Location Address: 1203 N. Federal Highway, Hollywood, Florida 33020

Technical Advisory Committee  
City of Hollywood  
Development Services Planning Division

RE: Site Plan Design for 6,318 sf spa and restaurant  
Federal Spa and Restaurant  
1203 N. Federal Highway

DIAGRAM SHOWING VEHICULAR USE AREA AND LANDSCAPE

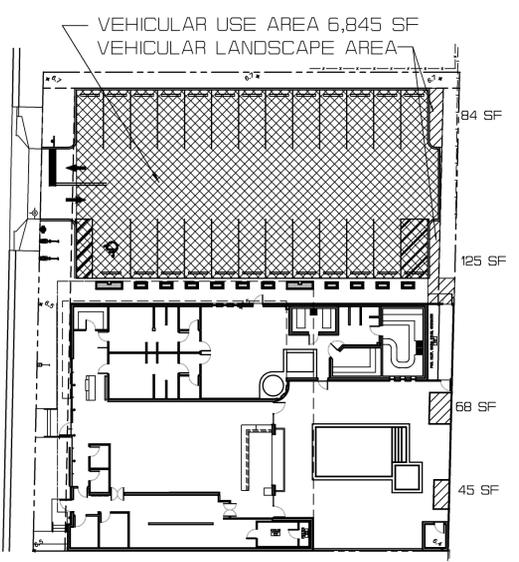
6. Provide Vehicular Use Area calculations in addition to a diagram depicting areas accounted for in the calculation of the vehicular use area. Calculations were submitted on the site plan but a diagram was not included. Per the regulations, 25 percent of the total square footage of the paved vehicular use area shall be landscaped. Percentage calculation excludes required perimeter landscaped setback area. Refer to Appendix 1: Regional Activity Center and Downtown Redevelopment Districts Diagrams, Diagram 17, in Article 4.6 of the Zoning and Land Development Regulations.

**Response: We have added an additional diagram to the site plan, DRC-2, which depicts the Vehicular Use Area. We are requesting a variance for the 25% landscape area. This is a very small site with limited area for parking. It is zero lot line on the three sides. Understanding that if we have a roof over the parking area, and it was a parking garage, we would not be required to have Vehicular Use Landscaping.**

**Response: Added a reduced site plan hatching vehicular use area and associated landscape.**

**FLOOR PLAN**  
SCALE: 3/16"=1'-0"

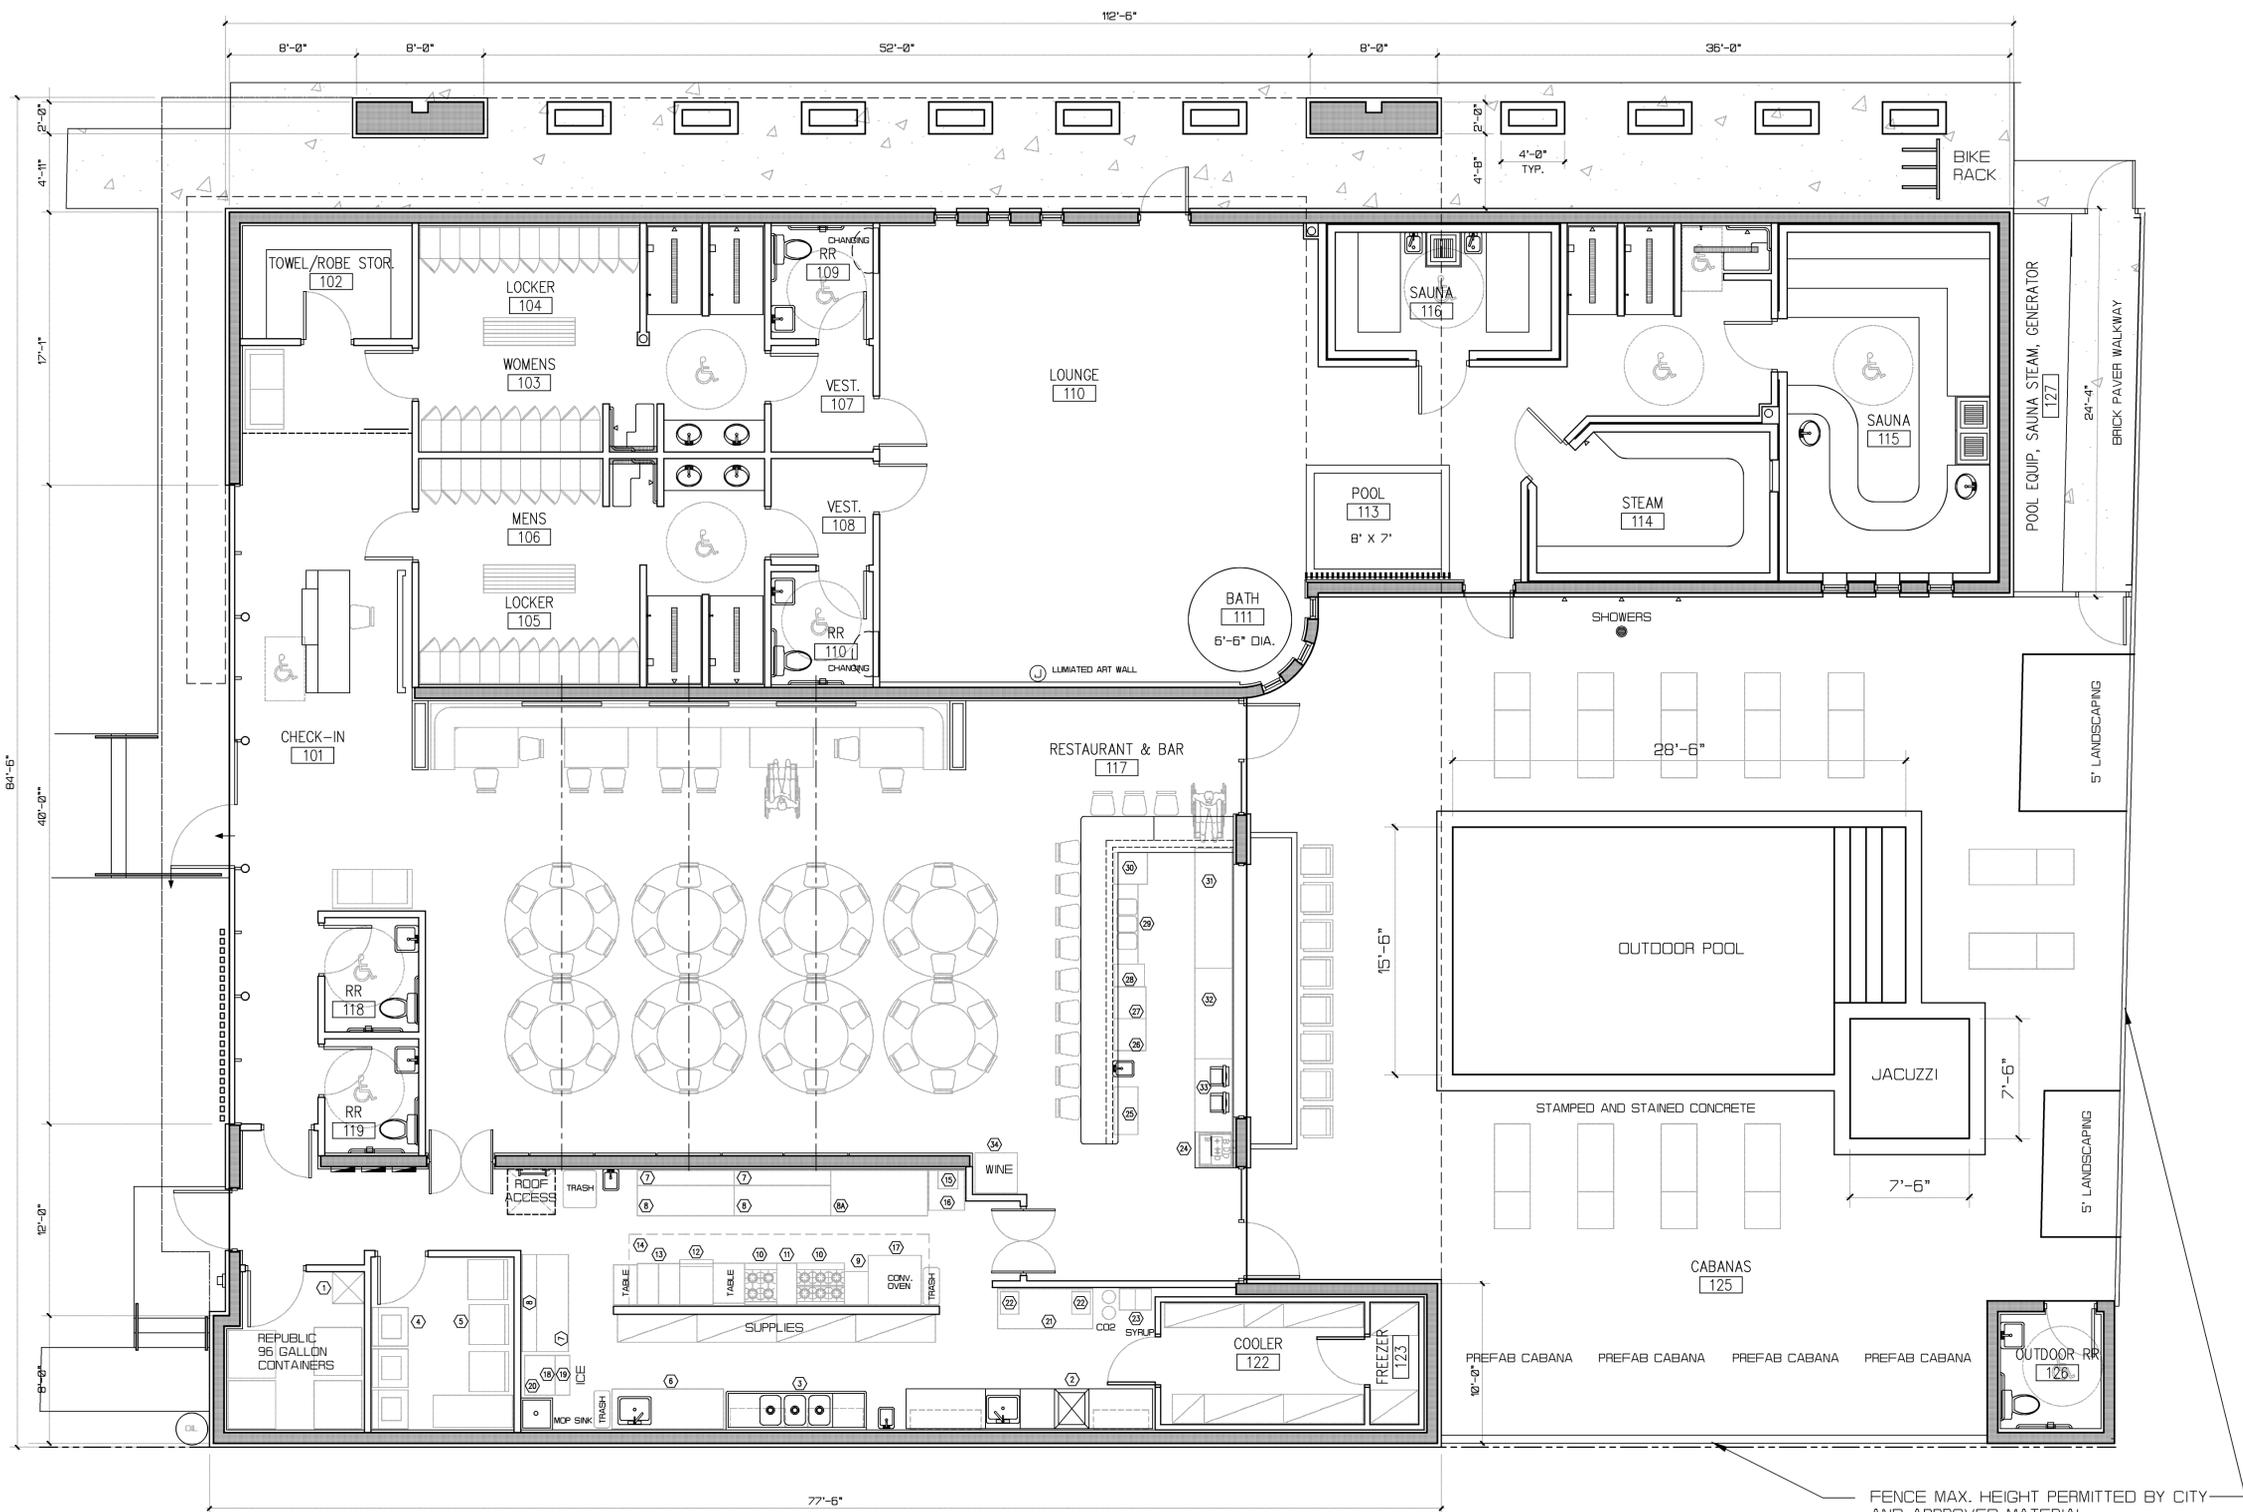
12. DRC-3 a. Bike racks must be located on impervious surfaces. Revise.

b. What are the dimensions of the planters? Define.

**Response: Added bike rack on impervious surface. Site plan.**

**Response: Added dimensions.**

WEST ELEVATION

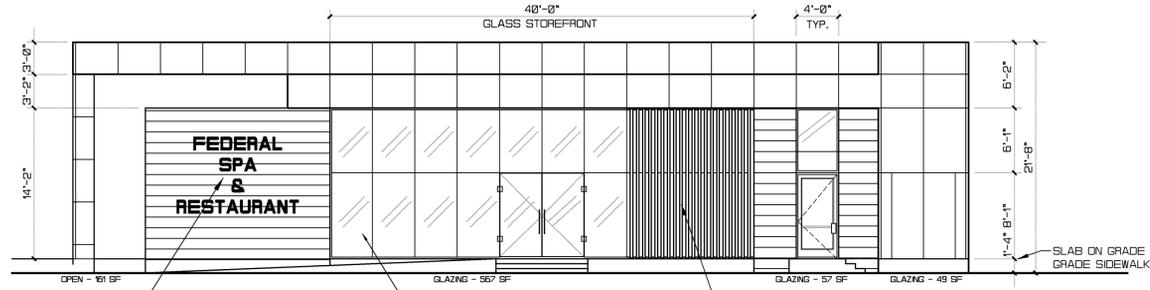
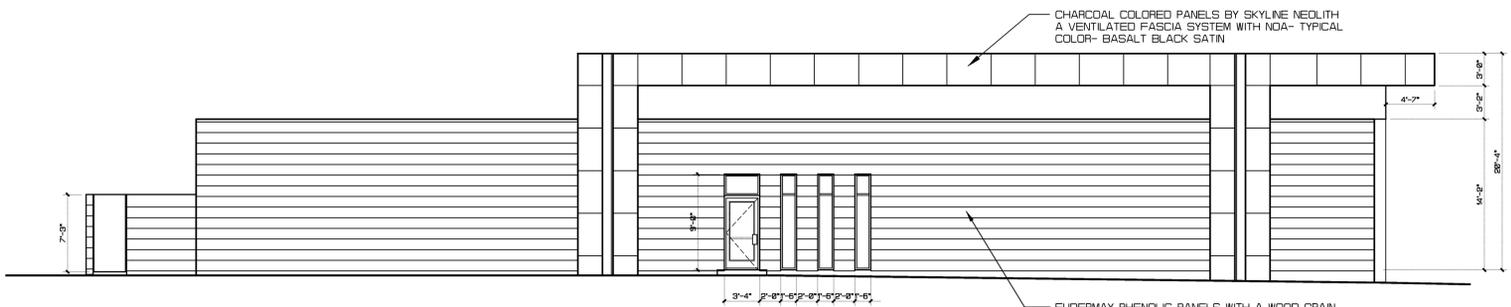
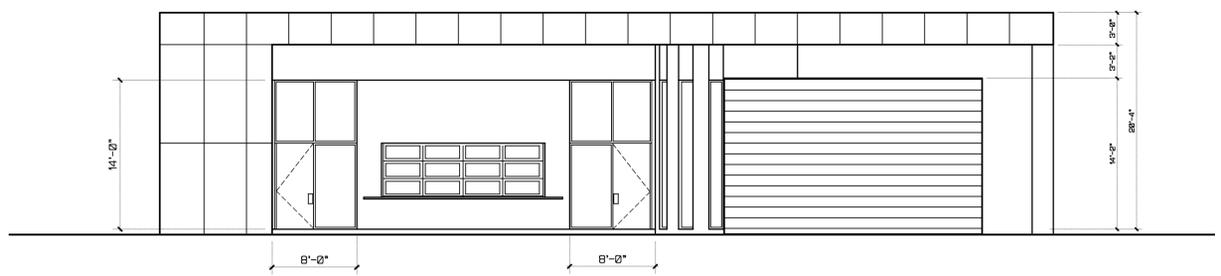
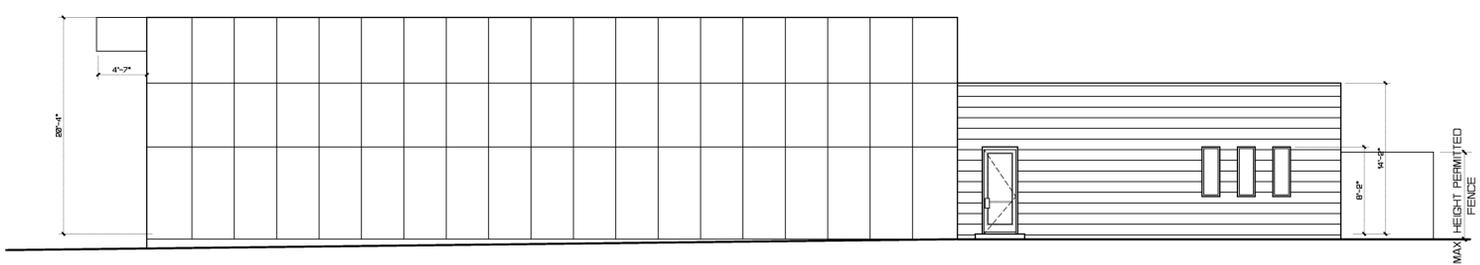
13. DRC-4 a. Roll up door is not reflected in renderings. Revise.

3. Provide color and materials legend for all elevations.

**Response: Roll up door removed.**

**Response: Added notes and legend to elevation sheet.**

**Tree Disposition Plan**

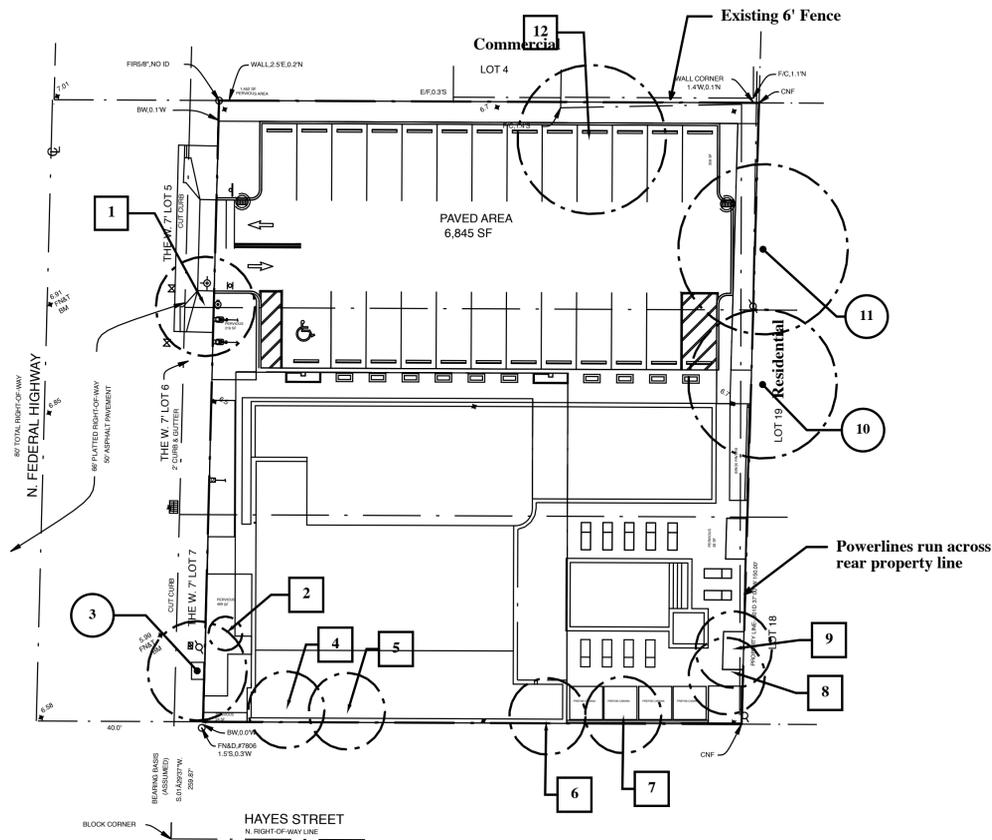
8. Provide tree survey as satellite images show additional trees on property. Show trees on adjacent lots that are within 10' from property.

9. Provide tree disposition plan with all existing trees/palms and their disposition. Trees are mitigated inch per inch and palms are mitigated 1:1.

**Response: Sheet TD-1 has been added to the set and shows all existing trees on the site.**

**Response: Sheet TD-1 has been added to the set and shows all existing trees on the site.**

**SHEET TITLE**  
 ENGINEERING  
 PLAN

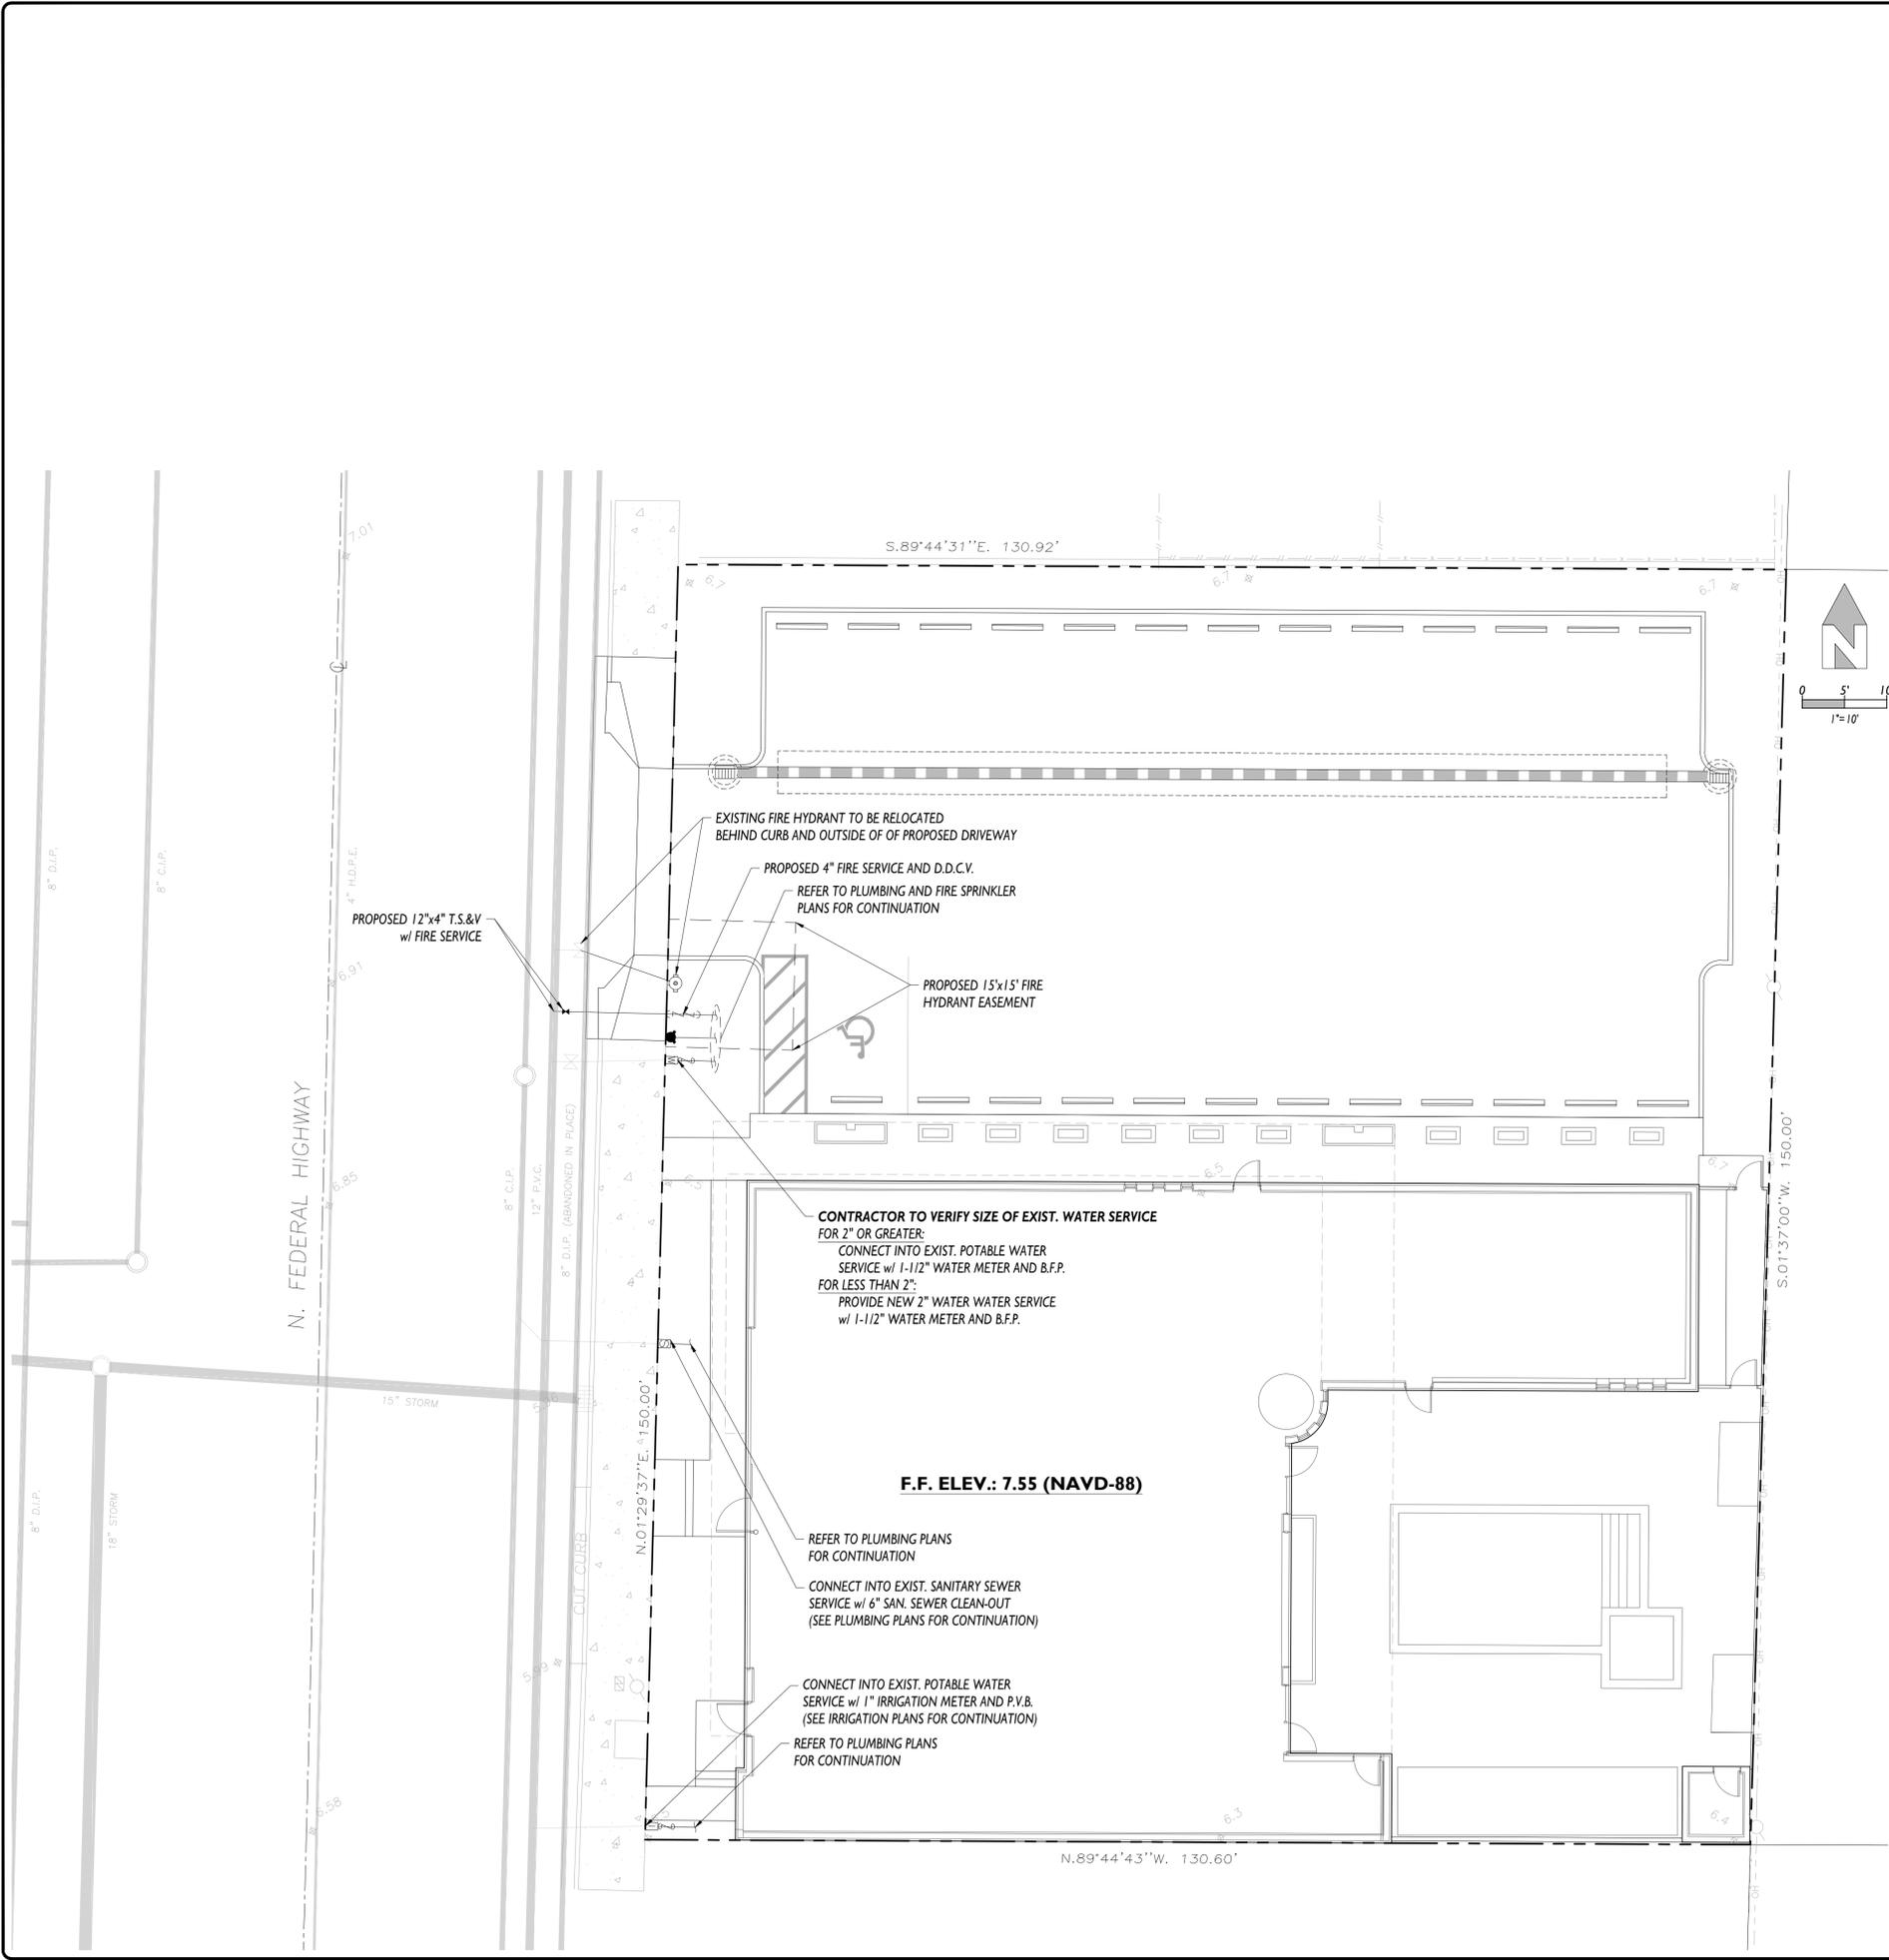
7. Provide additional cross sections across west and east property limits, through the driveway on the north side, and through the building on the south side, including transition areas meeting adjacent property grades.

**Response:** *The requested cross-sections have been prepared and are shown on the attached/ revised Engineering Plan (Sheet No. C-3.0).*
